# UNITED STATES PATENT AND TRADEMARK OFFICE

APPLICATION NO.	FILING DATE	FIRST NAMED INVENTOR	ATTORNEY DOCKET NO.	CONFIRMATION NO.
10/598,011	08/15/2006	Niculo Steinrisser	P30190	9108
7055 7590 09/16/2009 GREENBLUM & BERNSTEIN, P.L.C. 1950 ROLAND CLARKE PLACE RESTON, VA 20191			EXAMINER AMIRI, NAHID	
			ART UNIT 3679	PAPER NUMBER
			NOTIFICATION DATE 09/16/2009	DELIVERY MODE ELECTRONIC

<b>Office Action Summary</b>	<b>Application No.</b> 10/598,011	<b>Applicant(s)</b> STEINRISSER, NICULO	
	<b>Examiner</b> NAHID AMIRI	<b>Art Unit</b> 3679

## **DETAILED ACTION**

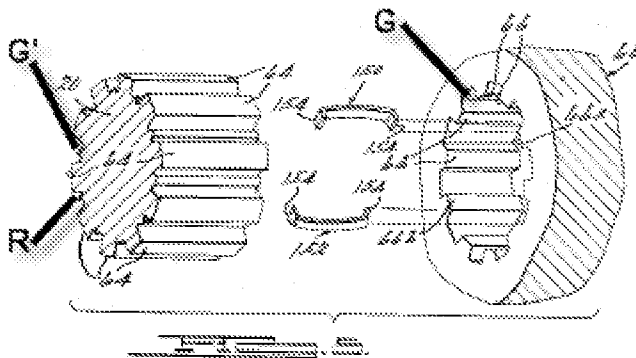
With respect to claims 12, 13 and 22, it is unclear what exact elements Applicant is referring to as "a groove head" and "a groove root" of the hub and the shaft. Further, claim 12, lines 4-5, it is unclear how the rib could also be projected from the grooves of the shaft and at the same time projecting towards the groove of the hub, since from the drawing it appears to be if the rib projects from the grooves of the shaft then the rib is going to be away from the groove of the hub instead toward the groove of the hub. Same applies to claims 13 and 22.

With respect to the above rejection, it should be noted that no point of reference has been defined to enable one to properly ascertain what constitutes the hub groove, etc. For example, is the part of the hub that projects into the shaft groove supposed to constitute the claimed hub groove because a groove is defined on the side opposite the projecting portion or are the hub recesses located to either side of this projecting portion supposed to be the hub groove that is being referred to in the claims? Further, as defined in the specification, the grooves of one component are offset from the grooves of the other component, e.g., note 3, 3' and paragraph [0028]. Accordingly, it would appear that the language as used in the claims does not correspond to what has been shown and described.

**FIG. 5**

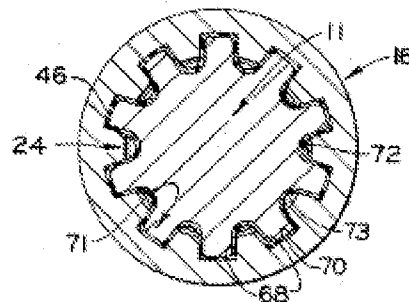
With respect to claims 22 and 31, Groves et al. disclose telescopic tube (Fig. 5) for drive shafts comprising an outer tube (16) having a plurality of grooves with an essentially quadrilateral groove cross section; an inner tube (11) having a plurality of grooves with an essentially quadrilateral groove cross section. Groves et al. fail to disclose at least one rib radially projecting from one of the grooves of the inner tube towards one of the groove of the outer tube, a radially inward surface of the groove of the hub forms a hub groove head and a radially outward surface of the groove of the hub forms a hub groove root; and a radially inward surface of the groove of the shaft forms a shaft groove root and a radially outward surface of the groove of the shaft forms a shaft groove head, wherein the at least one rib projects radially from the shaft groove root; and wherein at least one rib is formed in one piece from a material of the groove from which the at least one rib project . Powell discloses a groove profile for a positive hub-shaft connection comprising a outer tube (68) having a plurality of grooves (G) with an essentially quadrilateral groove cross section; a shaft (20) having a plurality of grooves (G') with an essentially quadrilateral groove cross section; at least one rib (R) radially projecting from one of the grooves (G') of the shaft (20) towards one of the grooves (G) of the other of the hub (68), a radially inward surface of the groove (G) of the hub (68) forms a hub groove head and a radially outward surface of the groove of the hub (68) forms a hub groove root; and a radially inward surface of the groove of the shaft (20) forms a shaft groove root and a radially outward surface of the groove of the shaft (20) forms a shaft groove head, wherein the at least one rib projects (R) radially from the shaft groove root instead of hub groove head; and wherein at least one rib (R) is formed in one piece from a material of the groove (G') from which the at least one

rib (R) project. It would have been obvious to one of ordinary skill in the art at the time of invention was made to provide the outer groove head of Groves et al. with at least one rib as taught by Powell in order prevent outer and inner tubes from disengaging from one another.

With respect to claim 24, Groves et al. disclose (Fig. 5) that the inner tube and the outer tube (11, 16) are hollow bodies each with an approximately uniform profile thickness; and wherein the essentially quadrilateral groove cross section is an essentially rectangular groove cross section.

With respect to claim 25, Groves et al. disclose (Fig. 5) that the essentially quadrilateral groove cross section is an essentially rectangular groove cross section.
